# **RESPONSE TO SUBMISSIONS**

## **UNSW CLIFFBROOK (SSD 8126)**

17 OCTOBER 2017  
PREPARED FOR UNIVERSITY OF NEW SOUTH WALES

Figure 1 – Eastern Elevation

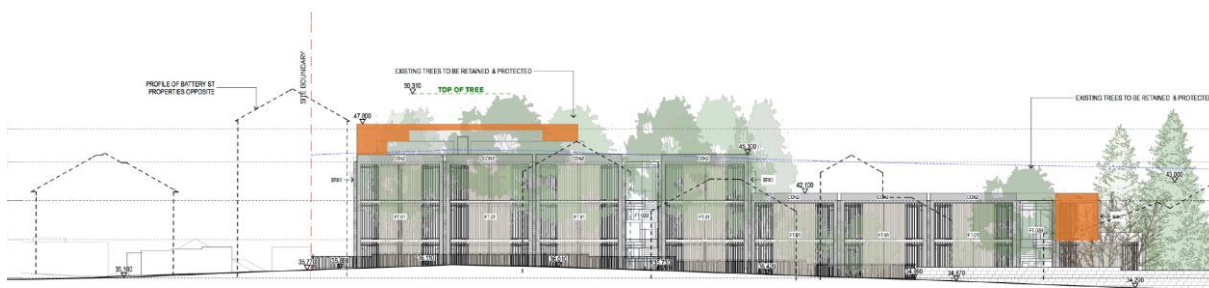
#### 5.1.1. Review and reduce the north-eastern corner

In response to DPE's preliminary assessment and the submissions, the north eastern corner of the new building has been reviewed and amendments to reduce the impact on the streetscape on Battery Street and residents have been made. FJMT reviewed the bulk, height and streetscape appearance and propose the following design amendment as part of the RTS:

- The bulk of the north eastern corner is reduced through a 0.7m reduction in height of the roof plant and removal of the stairs,
- Relocated a bedroom from Level 2 on the north western end on Battery
- Reduced the parapet around the roof plant
- Reviewed the materials and finishes along Battery Street.

Revised elevations have been prepared and are submitted as part of the amended drawing set, however the figures below assist in articulating where the proposed reductions in bulk and form have occurred (as indicated in orange).

Figure 4 – View assessment – J1 (44 Beach Street)

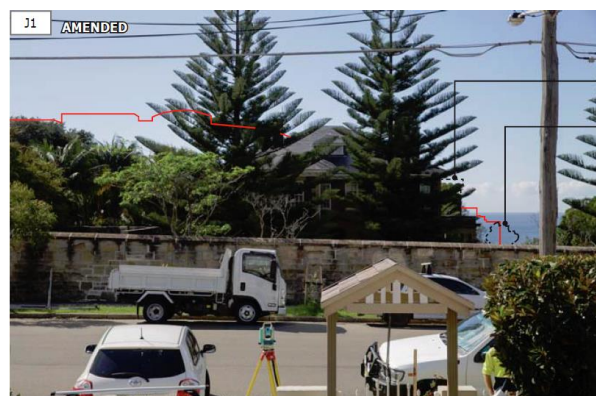
Given the direction provided by the DPE on view impact issues, and also having regard to the design recommendations by GMU, the project team has explored ways of improving views from these two properties.

- Lowering of the roof by 700mm above the lounge area in the east wing of the development (refer Picture 4 below)
- Removal of the roof overhang of the east wing of the development (refer Picture 4 below)

GMU have re-assessed the potential view impacts of J1 and J2 (i.e. 44 and 46 Beach Street) and provided a further assessment and response in an *Addendum to the Visual Impact Assessment*. This report concludes,

*GMU considers that the proposal has changed positively in both Views J1 and J2. The level of view impacts on View J1 has reduced from ‘significant’ to ‘minor-moderate’ and the level of view impacts on View J2 has reduced from ‘significant’ to ‘moderate’. Both Views are now considered acceptable from a visual impact point of view and therefore they do not require any further design changes”.*

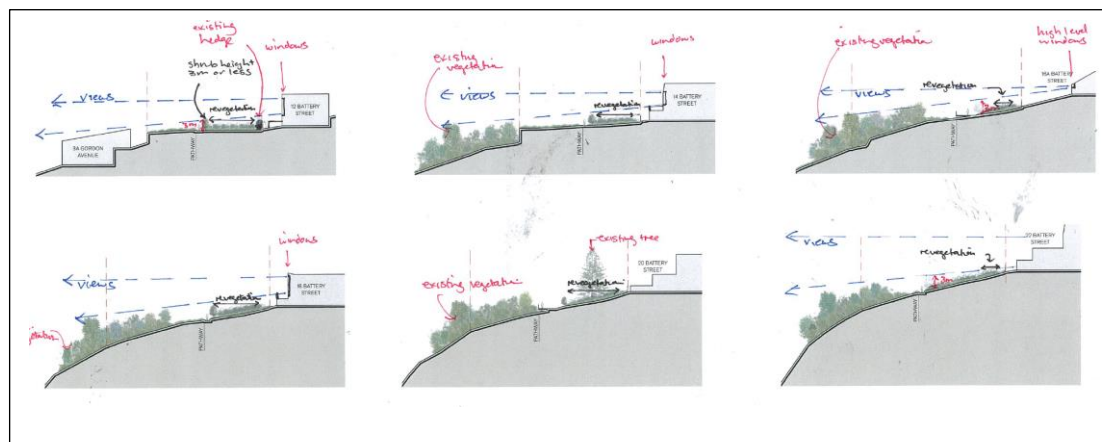
View loss to ocean and Gordons Bay cliff face from 5 Battery Street	GMU Addendum report states, “ <i>As recorded in View F1 of the VIA report, the property does not show views of the Gordon Bay’s Cliff, but enjoys a corridor of ocean views to the southeast. At 4 storeys, the proposal would largely be screened by existing vegetation. The maximum height of</i>

<p><i>the proposal stays below the top of the tree canopies and the building does not appear to be prominent.</i></p> <p><i>Most importantly, the existing ocean views, which are the most valuable view element for this property, will be fully retained.</i></p> <p><i>Therefore, GMU's visual impact assessment considered that the potential visual impact on the property's living room is nil and acceptable."</i></p>
<p>View analysis does not take into consideration the approved DA 468/2015 of 1A Battery Street (which is yet to be constructed).</p> <p>Lack of view assessment generally for 1A Battery Street.</p>	<p>Refer to Page 6 of GMU's <i>Addendum</i> assessment which provides a detailed explanation of the visual impact assessment from 1A Battery Street.</p>
<p><u>Visual (Beatty Legal)</u></p> <p>The proposed planting in the vicinity of the Path will use vegetation that, in the long- term, will grow to a significant height. While this may take several years to manifest, the growth will result in a substantial obstruction of the most desirable and valuable views from our clients' properties.</p>	<p>The Revegetation Zone in the Eastern portion of the site is not the full extent of the foreshore area. The majority of the eastern portion is marked for regeneration works as opposed to revegetation works (where regeneration works do not include new planting).</p> <p>UNSW is not obliged to regenerate or revegetate anything, however UNSW and the project team saw this project as an opportunity to undertake due diligence and be a good steward of the land.</p> <p>A good biological outcome can be achieved if the proposed revegetation mix was altered to include grass, ground cover and shrub species only - the floral community would not be as diverse but the overall outcome would be an improvement for the foreshore environment.</p> <p>Narla provided the further comment in relation to the revegetation area of the site, "<i>It is my professional opinion that the aims of improving floristic diversity, and habitat within and around the bushland remnant can be achieved through the planting of groundcovers and shrubs that are estimated to remain below 2.5 metres in height...</i></p> <p><i>I am comfortable that the aims of increasing biodiversity and habitat on the subject site can be achieved through restricting plantings (in the area identified by the concerned residents) to species that do not usually exceed 2.5 metres in height".</i></p>
